SUBMISSION ON THE NEM RELIABILITY SETTINGS: INFORMATION, SAFETY NET AND DIRECTIONS RULE

NEMMCO Submission on NEM Reliability Settings: Information, Safety Net and Directions Rule**Attachment: Detailed Comments**

Figure 1: Current project timelines for full EAAP implementation

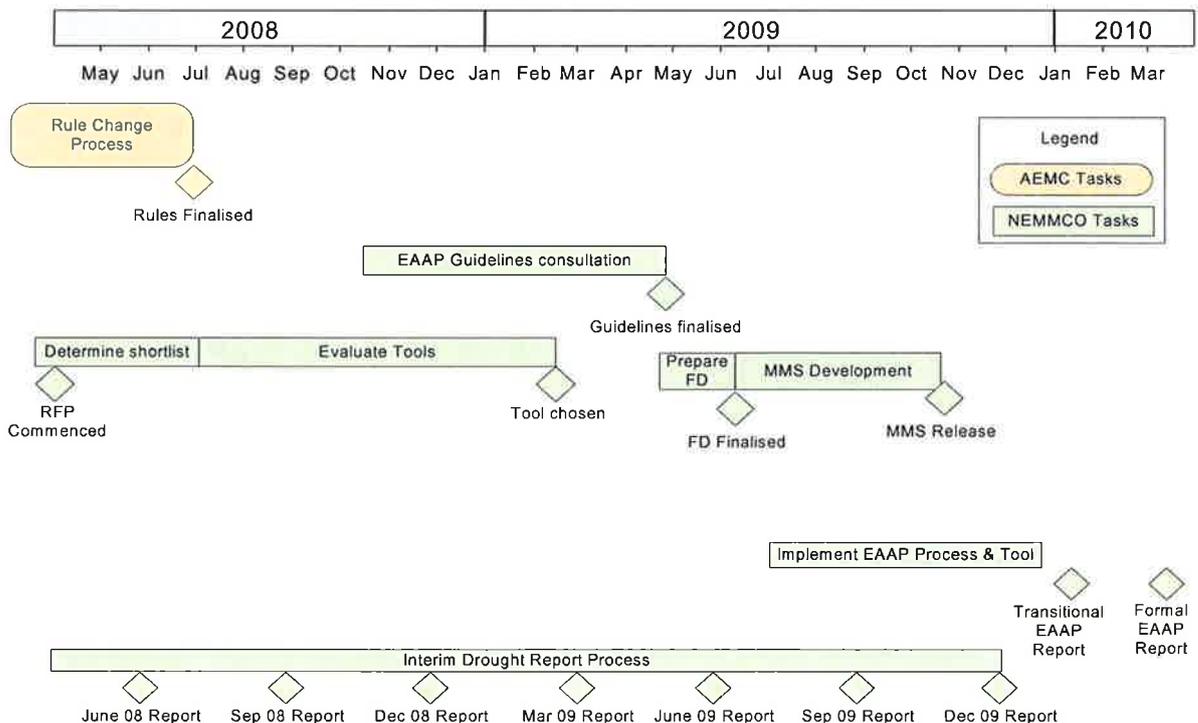
Taking into account the draft Rule published by the Commission, and the implementation steps that NEMMCO needs to carry out to fully implement the EAAP, Figure 1 shows NEMMCO's current high level timeline for the work.

As can be seen from Figure 1, the project includes tender process for procurement of a more appropriate modelling tool to support the EAAP – that tender process is currently in progress, with a Request for Proposal (RFP) having recently taken place. The anticipated completion date for full implementation of the EAAP is December 2009, following implementation of the EAAP software through a scheduled release of the NEM market management systems in November 2009. Following implementation, NEMMCO is planning to run the EAAP process for the first time, covering the two year period from 1 November 2009 – the output of that run would be published as a transitional run of EAAP in early 2010, after any issues with the process and the output have been resolved. The same period will already have been covered by the drought impact report published in the fourth quarter of 2009 so the transitional EAAP and the

NEMMCO is therefore seeking for the date appearing in draft Clause 3.7B(d) to be moved back by three months to be 31 March 2010. The date for determination of the first EAAP Guidelines, 30 June 2009, fits well with the implementation program.
